Meeting Date: Tuesday 17 March 2015
Location: Committee Room 2, Level 5, Civic Centre, 1 Devlin Street, Ryde
Time: 5.00pm

Item		Page
1	CONFIRMATION OF MINUTES - Meeting held on 3 March 2015	1
2	40 ANTHONY ROAD, DENISTONE – LOT 115 IN DP 305219. Development Application for a multi dwelling housing development containing 5 units and strata subdivision. LDA2014/0133.....	4

Report prepared by: Creative Planning Solutions; Team Leader - Assessment
Report approved by: Manager Assessment; Group Manager - Environment and Planning
File Number: GRP/09/5/6/2 - BP15/214

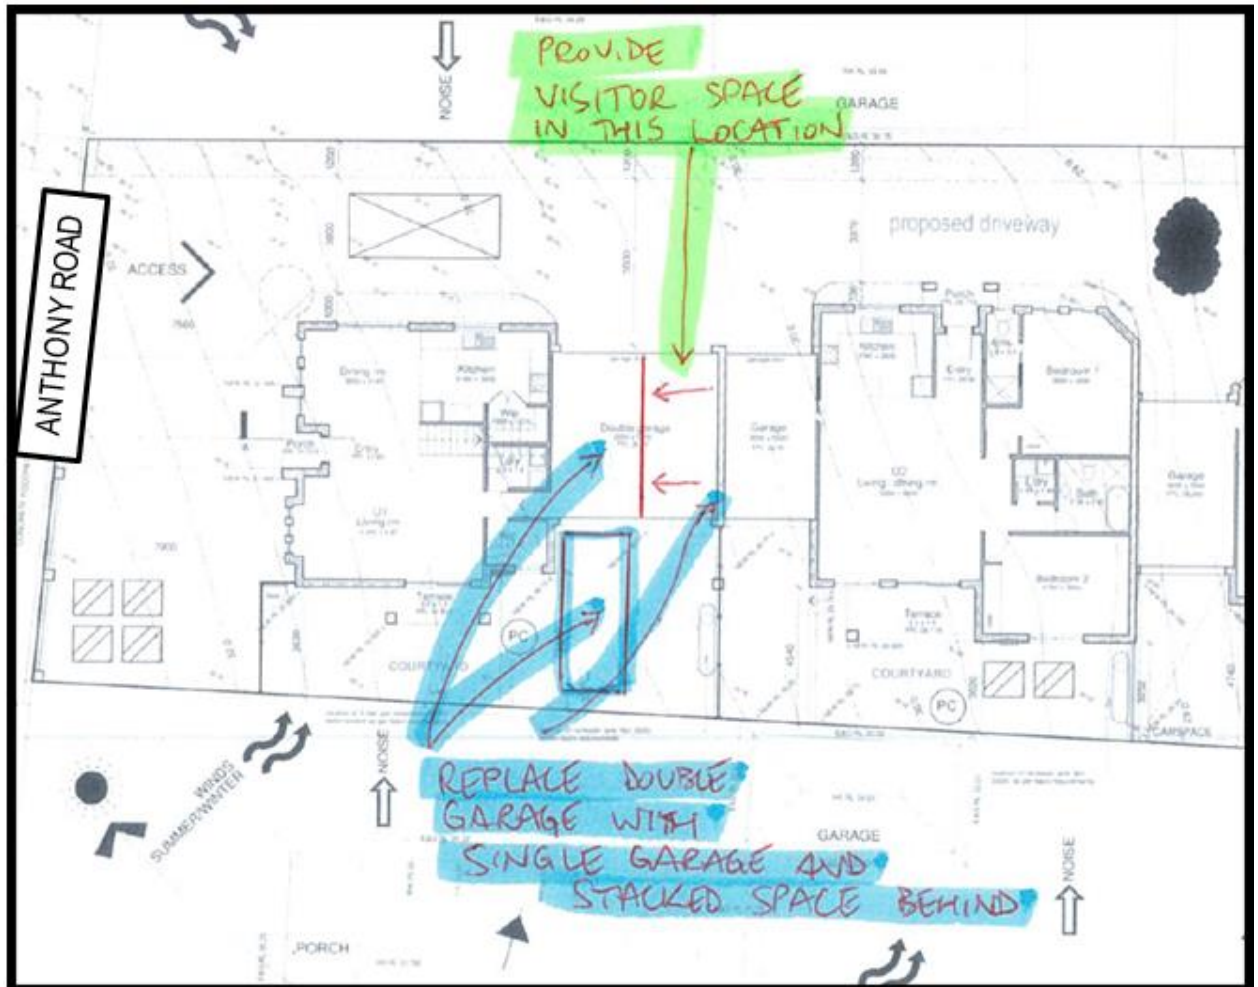
For multi-dwelling housing developments of 5 units, Council has consistently required 2 visitor parking spaces in accordance with the rounding up requirement in DCP 2014. Accordingly, it is considered that the development plans should be amended to ensure compliance with this requirement and provide 2 visitor spaces.

It is considered that this could be resolved via a Deferred Commencement condition of consent, and could involve a relatively minor change to the design, for example it is suggested that the design of the garage for dwelling 1 could be changed from a traditional double garage to a stacked parking arrangement, to provide a visitor space between units 1 and 2 (as shown in the diagram below). These amendments will ensure that the development complies with the minimum parking requirements in DCP 2014, to address resident concerns regarding the amount of on-site parking provided in the development.

- 2. Plan Amendments.** The submission of amended plans for Council's approval which provide the following plan amendments:
 - Visitor Parking – a minimum 2 visitor parking spaces being provided for the development.

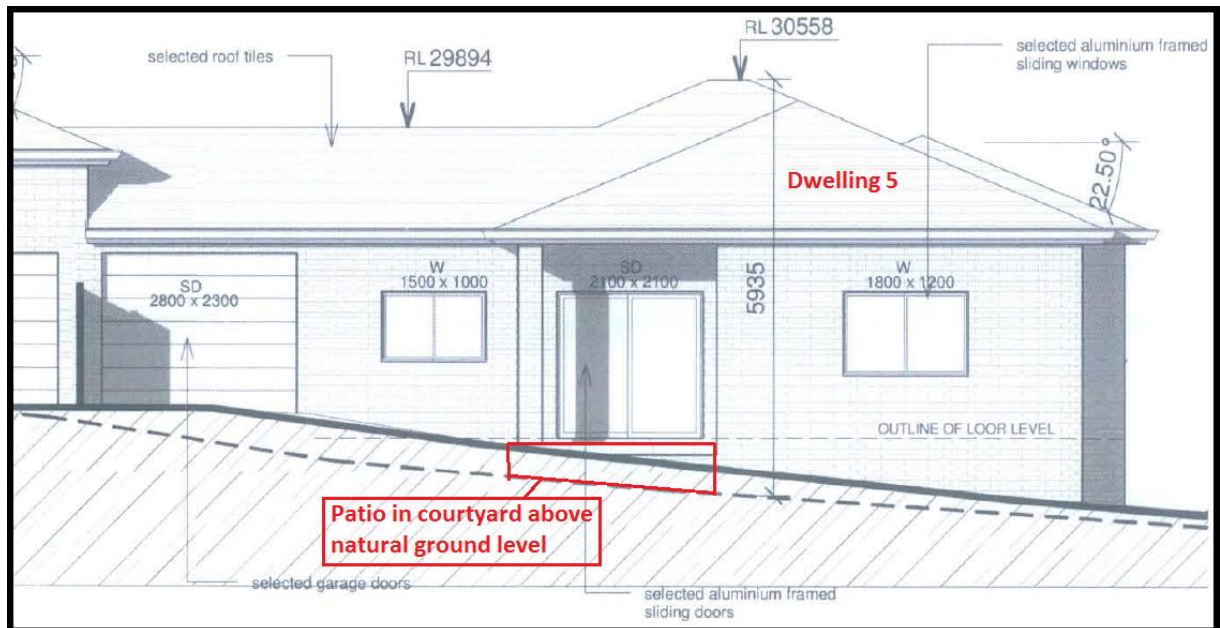
One concern that has been raised with the subject proposal, is the possibility of overlooking being presented from the courtyard area of Dwelling 5. This is depicted in in **Figure 5** below. It is recommended that this issue be resolved via provision of 300mm high lattice on top of the existing boundary fencing to the side/rear boundaries.

Lattice screening. *The provision of a lattice screen 300mm high on top of the northern side boundary fence adjacent to Dwelling 5. Details of compliance are to be provided in the plans for the **Construction Certificate**.*

Figure 8 – Side setback non-compliance.

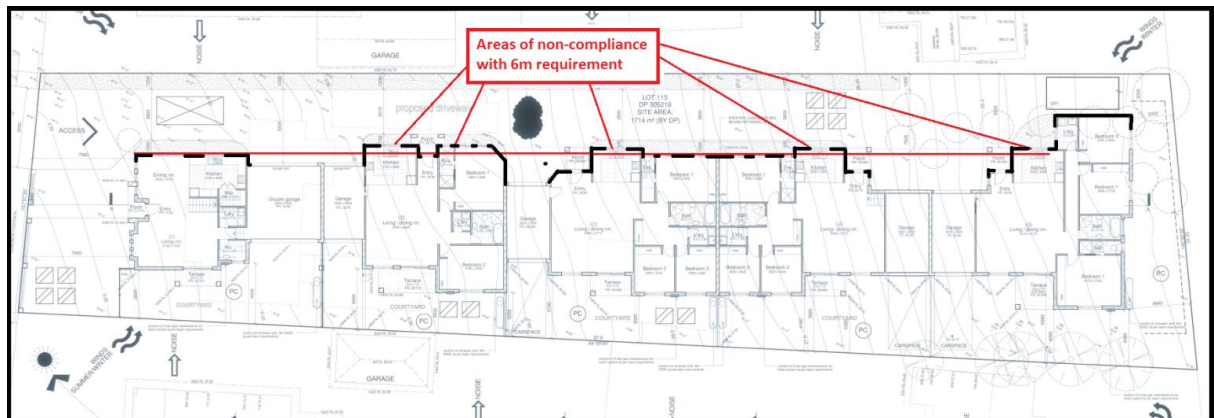
- The minor reduction in side setback is not considered to result in any unacceptable loss of visual or acoustic privacy impacts to adjoining development. This is because four (4) of the five (5) dwellings within the proposed development are single storey only. The only two (2) storey dwelling is Dwelling 1 located at the front of the site. For this dwelling, all living room areas have been positioned on the ground floor, with only bedrooms, bathrooms and a walk-in-robe located on the first floor of the dwelling. As such no unacceptable overlooking opportunities are considered to present themselves to adjoining property.

- The minor reduction in side setback is not considered to result in any unacceptable overshadowing impacts of adjoining property; and
- The proposed development, with its compliant building height, bulk and scale, is not considered to pose an unacceptable visual impact on adjoining property.

Figure 9. Section diagram for Dwelling 1, Dwelling 2 and Dwelling 3 demonstrating that the proposal includes a combination of cut and fill to minimise the level of land alteration. In this diagram the blue highlighted areas represent cut, and the red highlighted areas represent fill.

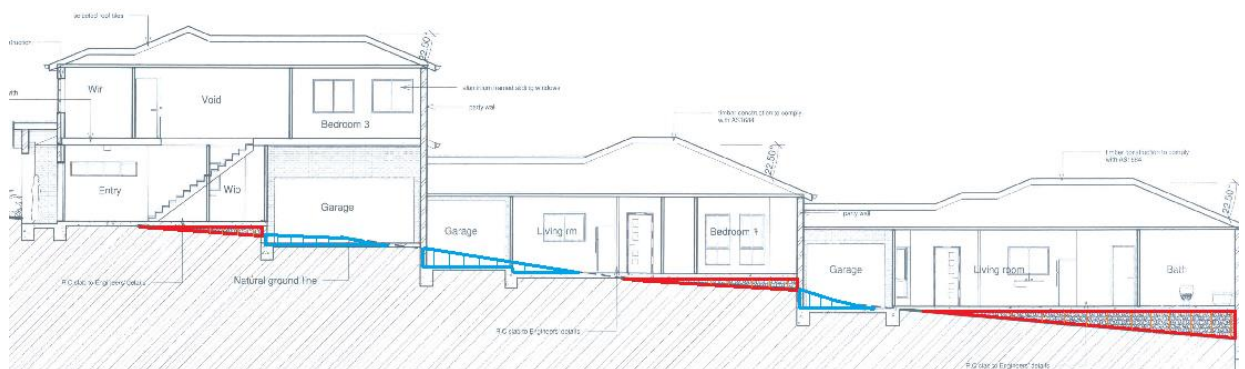
Although exceeding the maximum level of alteration permitted, this non-compliance can be supported for the following reasons:

- Given the steady slope of the site, the exceedance of a maximum of 300mm above the control is considered to be minimal.
- As demonstrated in **Figure 9** and **Figure 10** below, a combination of cut and fill in a balanced fashion has been utilised to minimise the level of land alteration.
- The alteration of levels in the courtyards along the northern boundary will make them flatter and hence more usable spaces. This will provide future residents with an enhanced level of amenity in their private open space areas.
- Minimal alteration of the levels throughout other areas of the site, including along the driveway on the southern side is proposed.
- The proposed levels of cut and fill will not result in any privacy impacts for the neighbouring properties. Refer to the 'submissions' section of this report for a full discussion of the privacy impacts of the proposed development.

Figure 11: The above diagram illustrates the portions of landscape strip adjacent to the driveway and dwelling which do not comply with the provisions of the Landscaping controls contained within Part 3.4 of Ryde DCP 2014.

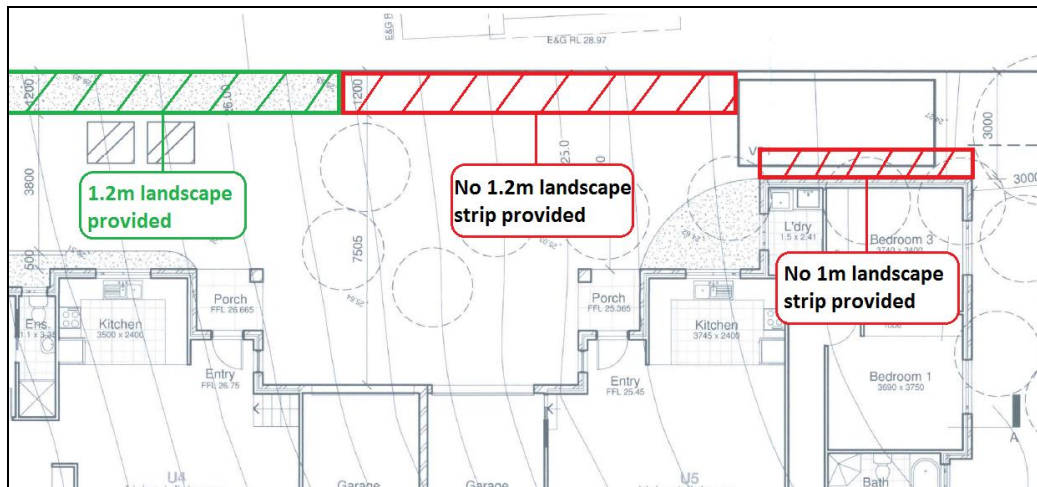
The development proposes a landscape strip between the proposed driveway and adjoining property, however the planting strip does not extend for the full length of the driveway. The landscape strip terminates approximately in line with the garage of Dwelling 4 – in order to assist facilitate vehicle manoeuvring. Additionally, the plans indicate that a landscape strip has not been provided adjacent to part of Dwelling 5 in accordance with the provision above and some planting beds do not conform with the minimum 1m width but are reduced to 500mm. Accordingly, portions of the landscaping on site do not comply with the requirements of the aforementioned control.

- The landscaping adjacent to Dwelling 5 has been purposefully omitted to allow sufficient area for the visitor's parking space.
- The width of planting beds adjacent the dwelling which are 500mm are considered to be sufficient given they are capable of accommodating vegetative planting and are opposite the adjacent landscaping strip which has a width of 1.2m in these locations.

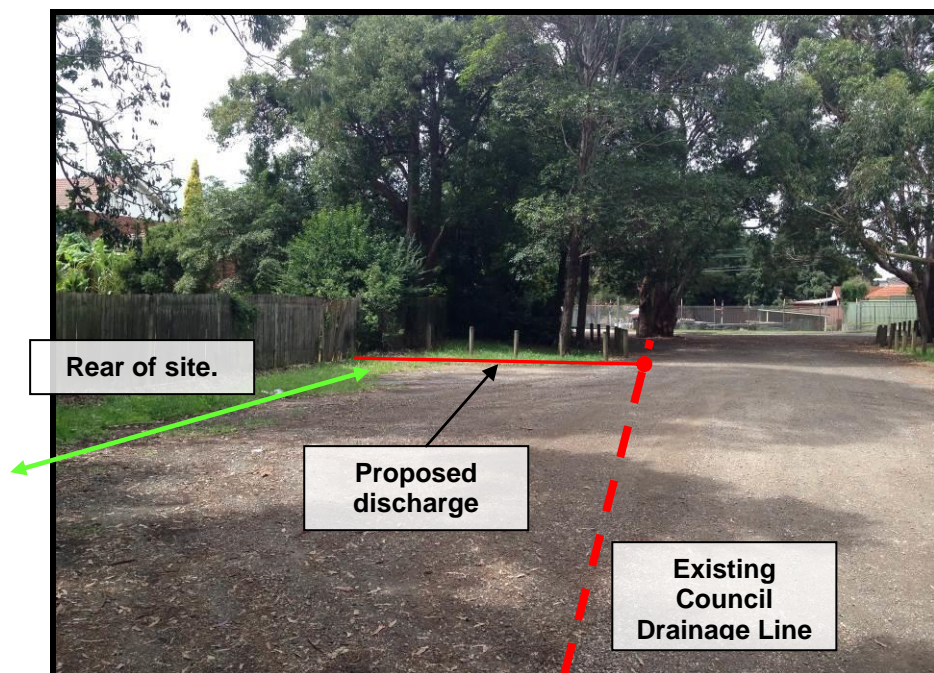
That the applicant be requested to provide details that have been prepared by a suitably qualified person (ie Accredited Fire Safety Engineer) to address the deficiency in street hydrant coverage and carriageway width.

Assessment Officer's Comment: The above documents (referenced in the comments above) are guidelines for development that have been provided by NSW Fire and Rescue. Whilst they do not have statutory force in determination of this DA, they deal with a critical issue (fire safety, and the ability of NSW Fire Brigade to respond to a fire emergency) and therefore it is appropriate for these to guidelines to receive compliance wherever possible.

It is considered that compliance with these guidelines can be achieved via a condition of consent (see Deferred Commencement Part 1 condition 3 in the Draft Conditions attached). This may involve installation of a sprinkler system within the rear-most units within the development, and/or installation of a feeder hydrant within the driveway.

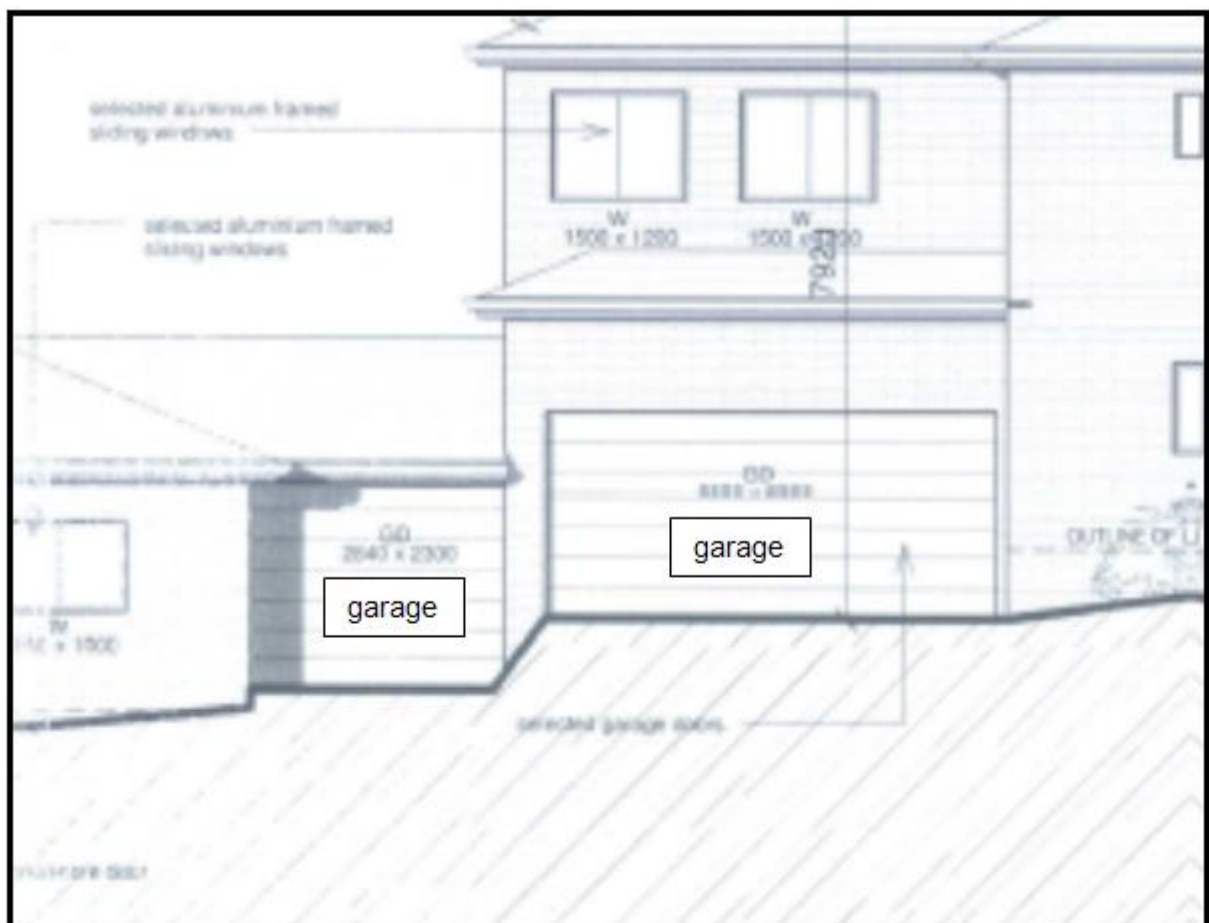
The following deficiencies were noted in the initial review;

- The access aisle width (manoeuvring area) for vehicles accessing the double garage of Unit 1 is specified at 5.5 m and would impose on vehicle access. Scrutiny of this on the revised plans notes that the garage entry width is nominated at 5.0m, which is wider than required and therefore addresses this.*
